12 September 2016

**National Trust of Australia (Victoria) submission-in-chief
Melbourne Metro Rail Project EES hearing**

Figure 10. Scope of tree loss in Tom's Block based on Technical Note 47. 70 trees will have major Tree Protection Zone (TPZ) encroachment (>10%, marked red), 11 trees will have minor TPZ encroachment (<10%, marked yellow) (Image: City of Melbourne).

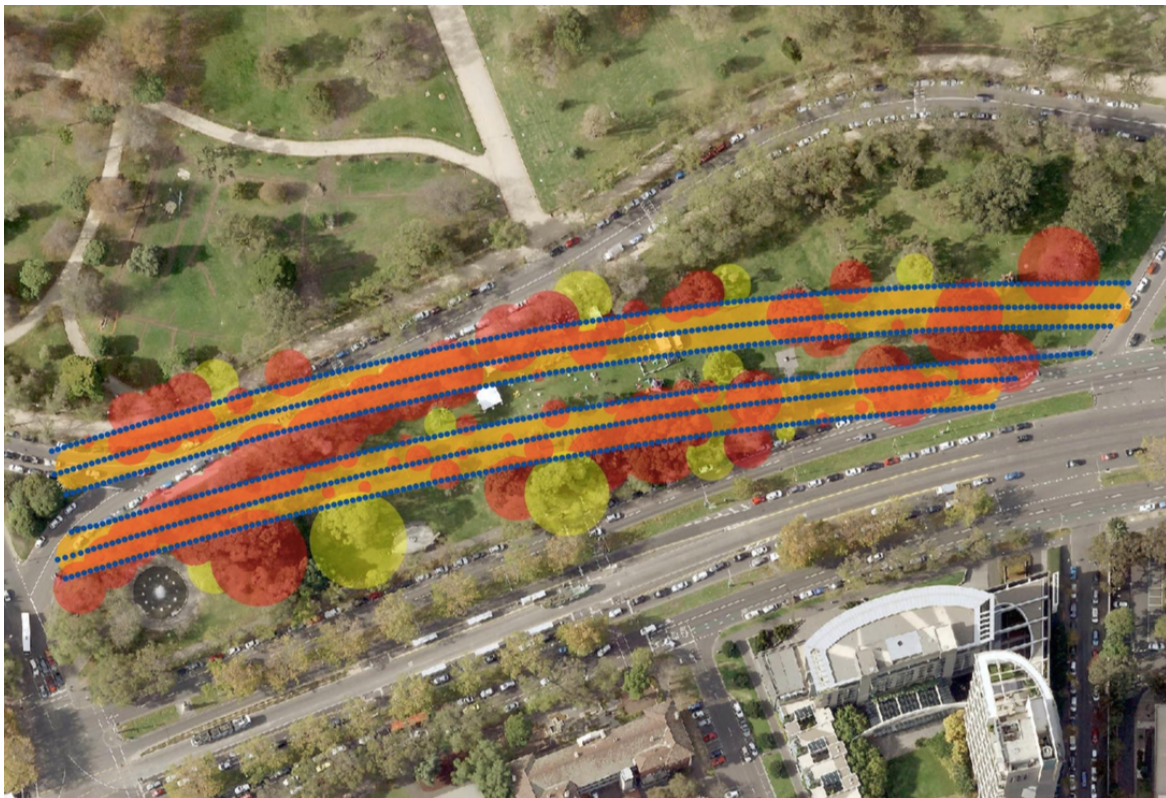
On the basis of Technical Note 47, Mr Shears' evidence was that he did not expect the trees to survive the proposed works and Mr Patrick's evidence was that more analysis of species is required to understand the impact of grouting on trees in the Domain. Mr Shears gave evidence that pumping cement into the soil would not be a precise procedure, with the liquid spreading under ground and expected to have a broader impact than that illustrated in Technical Note 47 – this is extremely concerning given the consequences for the treed landscape.

Mr Patrick characterised the canopy cover as dense within the Domain, and accepted that if the trees fail due to the concrete injection, there will be two linear scars across Tom's Block. Reading the figure provided by Mr Shears (Figure 10), there are only one or two existing trees currently in the centre alignment between the two lines of grouting. On this basis, this work will leave a scar more than 35 metres wide along the length of the 340 metre grouting area. By scaling off Figure 10, the scar will be more than 50 metres wide for approximately half the length of the grouting, increasing up to 75 metres wide in some locations as large trees adjacent to the works are subjected to major encroachment into their tree protection zones.

A 35- to 75- metre gap in the dense canopy cover of the Domain that extends over 340 metres is an unacceptable impact on the landscape and, in the National Trust's submission, is an impact so catastrophic that it cannot be adequately mitigated to ensure the broad character of the Domain is reestablished.

The National Trust strongly advocates for the lower alignment under the CityLink tunnels, as the upper alignment poses an unacceptable risk to the state significant Domain Parklands.

Figure 13. Finlay Avenue of Elms, Camperdown. Replacement trees have been boxed red to show relative growth rates. The smallest tree was replaced twice.

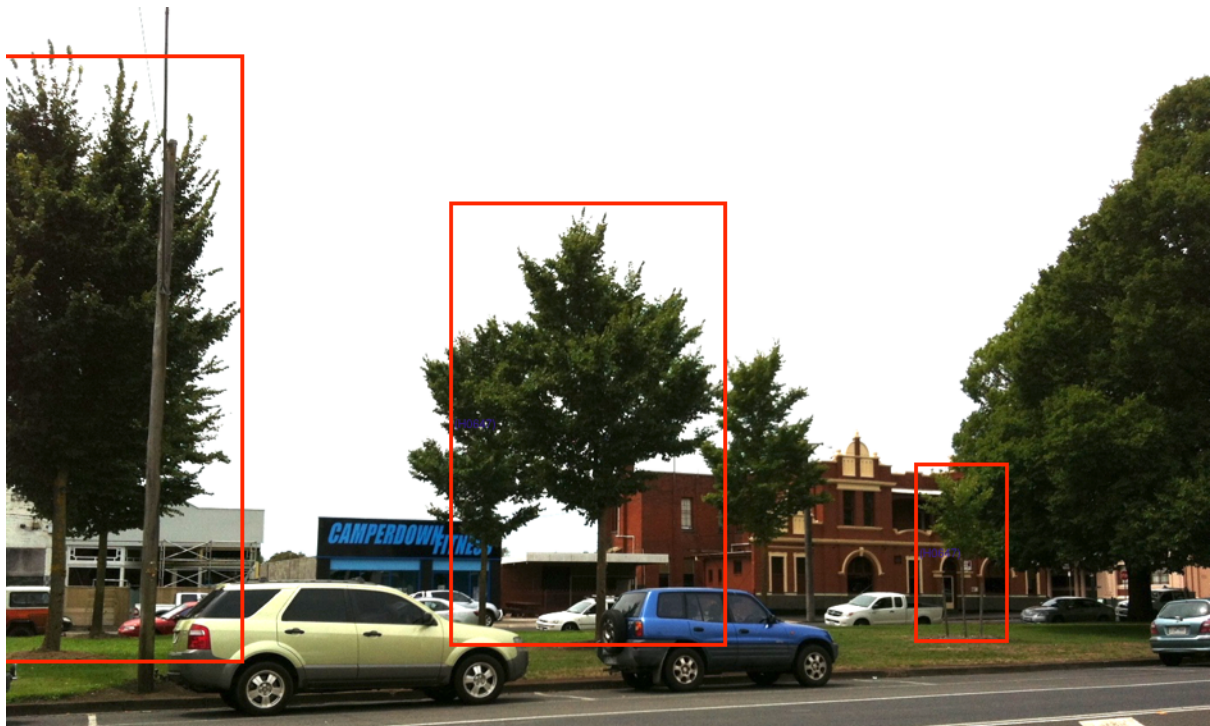
For the Committee's interest, Camperdown provides an example of an elm avenue on the Victorian Heritage Register (H0647) which is currently undergoing block replacement of trees. It is clearly visible that the replacement trees closest to the heritage trees are showing less vigour – they have only grown to half the height of those that have not competed for resources with established trees.
